Seismic Walkdown Checklist (SWC)

Equipment ID No. 300043 per 9/17/2012 ~~30S37-PANEL~~ Equip. Class¹² (20) Control Panels & Cabinets
 Equipment Description HPCI Turbine Aux Lube Oil Pump Starter
 Location: Bldg. Reactor Floor El. 88 Room, Area R3-13
 Manufacturer, Model, Etc. (optional but recommended) _____

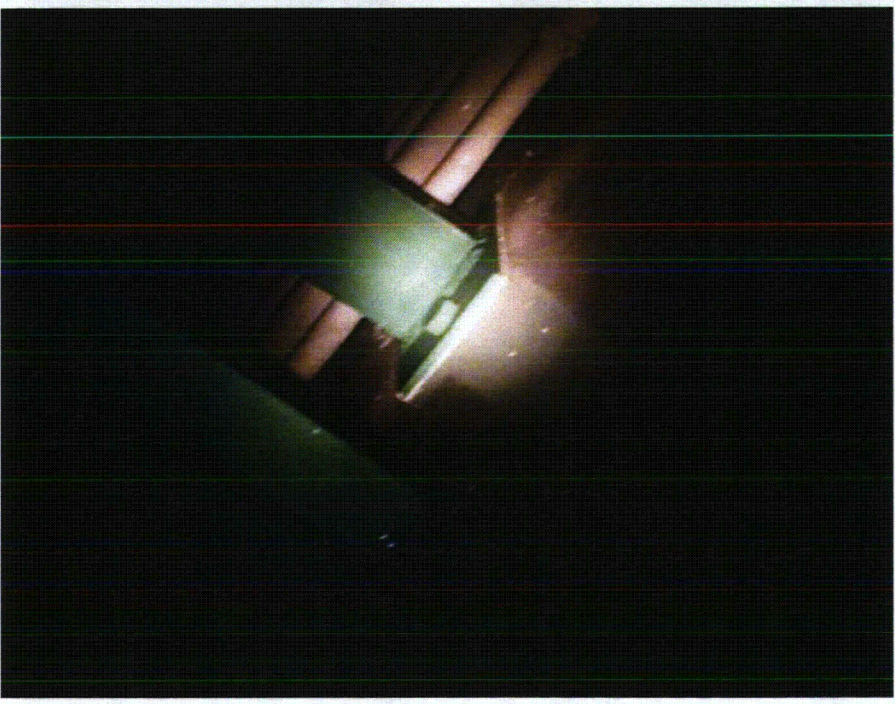
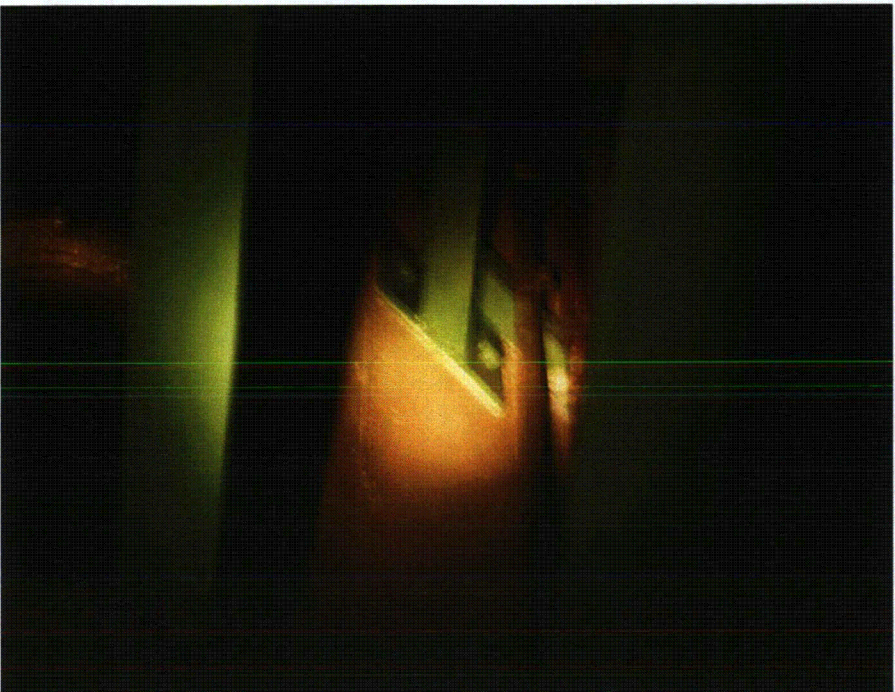
5. Is the anchorage configuration consistent with plant documentation? Y N U N/A
 (Note: This question only applies if the item is one of the 50% for which an anchorage configuration verification is required.)
ANCHORAGE DOES NOT MATCH DWG S-973, REV. 0, BUT AS-BUILT CONFIGURATION WAS EVALUATED IN CALCULATION PS-0927, REV. 0 AND JUDGED ACCEPTABLE. SEE COMMENTS 1061019.

Insulated pipe touching near support frame judged significant interaction gmr 9/11/2012 Y N U *credible but not*
